City of Norman ADA Self-Evaluation and Transition Plan Park Cost Projection Summary 5/1/2018

Site Accessibility Evaluation

201 W Daws St Norman, OK 73069

Accessibility Evaluation

Finding: 1

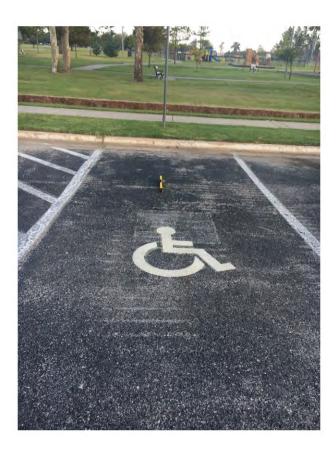
The running slope of the right accessible parking stall is between 3.0% and 5.7%.

Modify paving to achieve slopes no greater than 2% in all directions.

Finding: 2

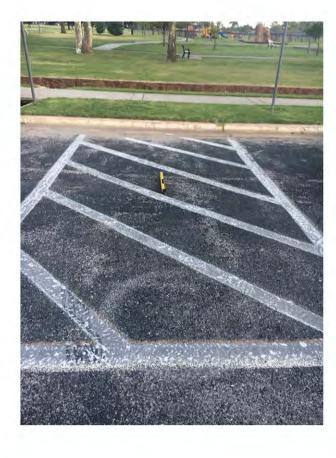
The running slope of the access aisle (long dimension) exceeds 2%.

Modify Paving to achieve slopes no greater than 2% in all directions.

Finding: 3

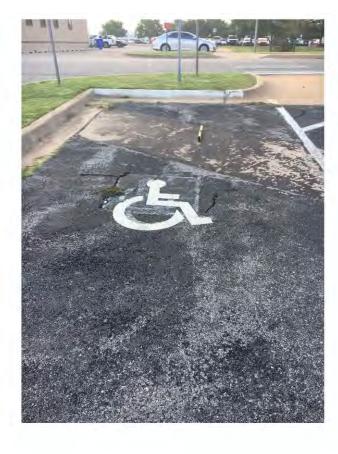
The running slope on the left parking space facing Daws has a running slope of 4.8%. Additionally, the pavement is cracked and broken.

Modify paving to achieve slopes no greater than 2% in all directions.

Finding: 4

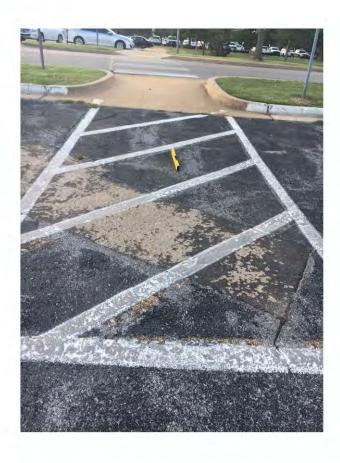
The access aisle facing Daws has a 6.6% running slope.

Modify paving to achieve slopes no greater than 2% in all directions.

Finding: 9

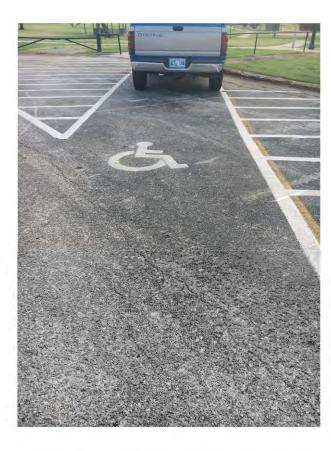
The accessible parking stall marked as "Van Accessible" is only 93" wide. In order to be van accessible, it must be a minimum of 96".

Restripe parking the van accessible parking space so it is a minimum of 96" wide.

Finding: 10

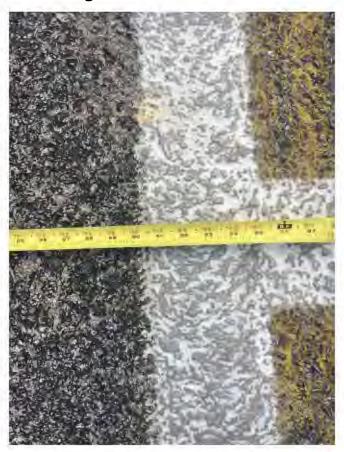
The path leading from the accessible parking to the sidewalk has cracked, uneven pavement.

Remove and replace concrete to achieve a smooth transition.

Finding: 11

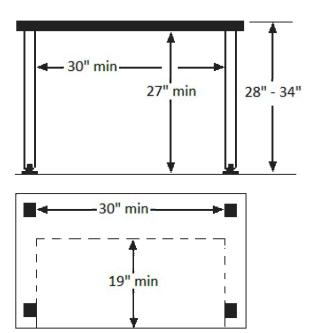
There are no accessible picnic tables provided at the Andrew's Park Building.

Provide an accessible picnic table.

Finding: 12

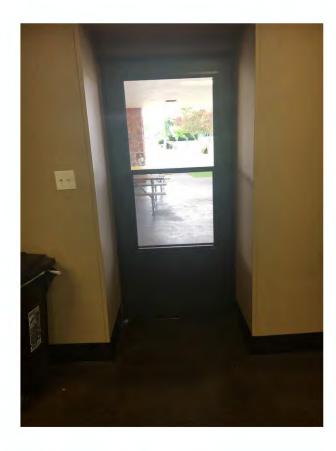
The door is recessed greater than 8" deep and does not provide the required clearance on the latch side of the door.

Modify door to provide the required clear floor space or provide an automatic door operator.

Finding: 15

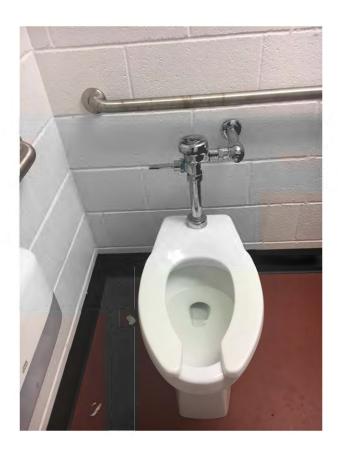
The flush handle is located on the closed/narrow side of the toilet.

Modify water closet to provide flush control on the open side of the water closet.

Finding: 17

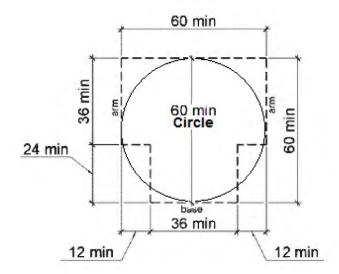
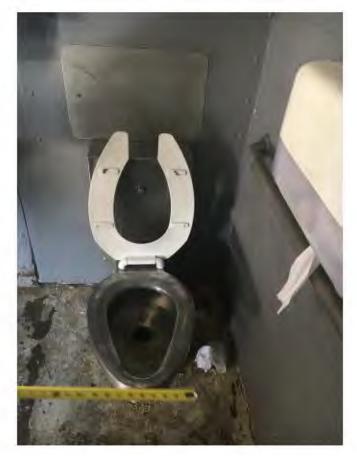
The restroom is not large enough to accommodate a wheelchair turning space. Additionally, the water closet and lavatory are not fully compliant.

Enlarge restroom to accommodate accessible water closet and lavatory and wheelchair turning space.

Finding: 20

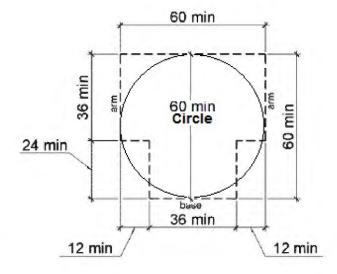
The restroom is not large enough to accommodate a wheelchair turning space. Additionally, the water closet and lavatory are not fully compliant.

Enlarge restroom to accommodate accessible water closet and lavatory and wheelchair turning space.

Finding: 23

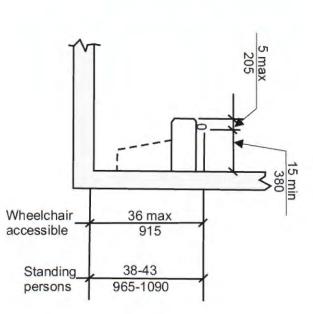
There is only one drinking fountain provided next to the Amphitheater

Provide a new hi/low fountain.

Finding: 48

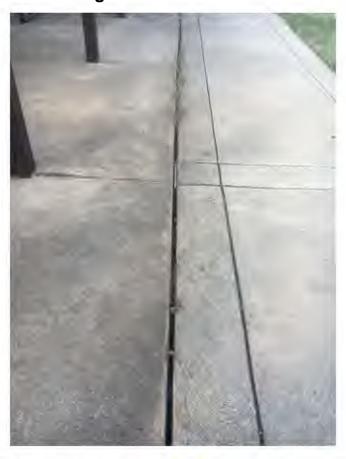
There are 9 picnic tables along the path, none of which have an accessible route to them. Additionally, none of these picnic tables are accessible.

Provide an accessible route to the picnic tables. In addition, replace one of the picnic tables with accessible tables.

Finding: 10

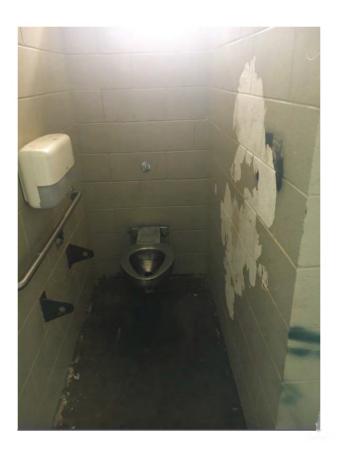
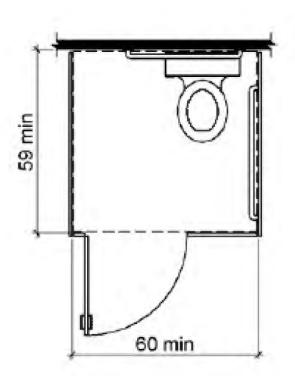
Wheelchair accessible compartments shall be 60 inches (1525 mm) wide minimum measured perpendicular to the side wall, and 56 inches (1420 mm) deep minimum for wall hung water closets and 59 inches (1500 mm) deep minimum for floor mounted water closets measured perpendicular to the rear wall. Wheelchair accessible compartments for children's use shall be 60 inches (1525 mm) wide minimum measured perpendicular to the side wall, and 59 inches (1500 mm) deep minimum for wall hung and floor mounted water closets measured perpendicular to the rear wall.

Modify restroom to provide an accessible toilet compliant.

Finding: 15

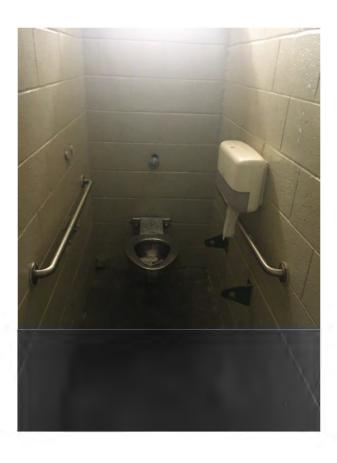
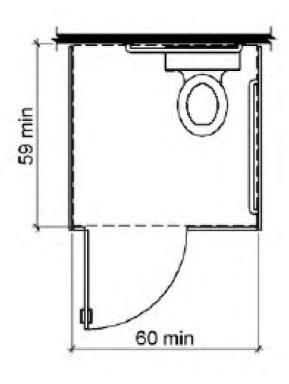
Wheelchair accessible compartments shall be 60 inches (1525 mm) wide minimum measured perpendicular to the side wall, and 56 inches (1420 mm) deep minimum for wall hung water closets and 59 inches (1500 mm) deep minimum for floor mounted water closets measured perpendicular to the rear wall. Wheelchair accessible compartments for children's use shall be 60 inches (1525 mm) wide minimum measured perpendicular to the side wall, and 59 inches (1500 mm) deep minimum for wall hung and floor mounted water closets measured perpendicular to the rear wall.

Modify restroom to provide an accessible toilet compliant.

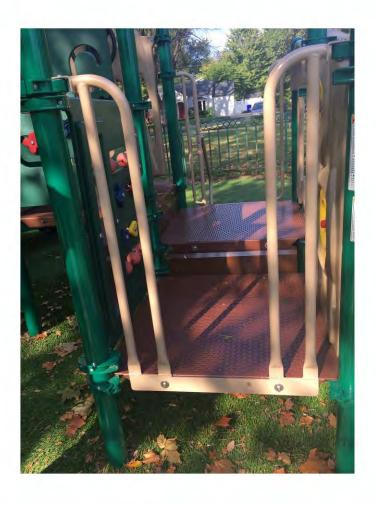
The clear width of accessible routes connecting elevated play components shall be permitted to be reduced to 32 inches (815 mm) minimum for a distance of 24 inches (610 mm) maximum provided that reduced width segments are separated by segments that are 48 inches (1220 mm) long minimum and 36 inches (915 mm) wide minimum.

Modify play structure to provide a clear opening of 32"

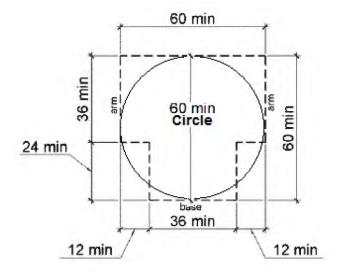
Turning space complying with 304 shall be provided within the room.

Enlarge toilet room to provide an accessible water closet and lavatory and wheelchair turning space.

Finding: 42

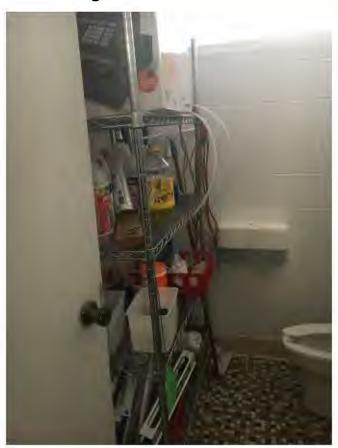
Signage is mounted on door and does not have Braille or tactile characters.

Provide signage with Braille and tactile characters on the latch side of the door.
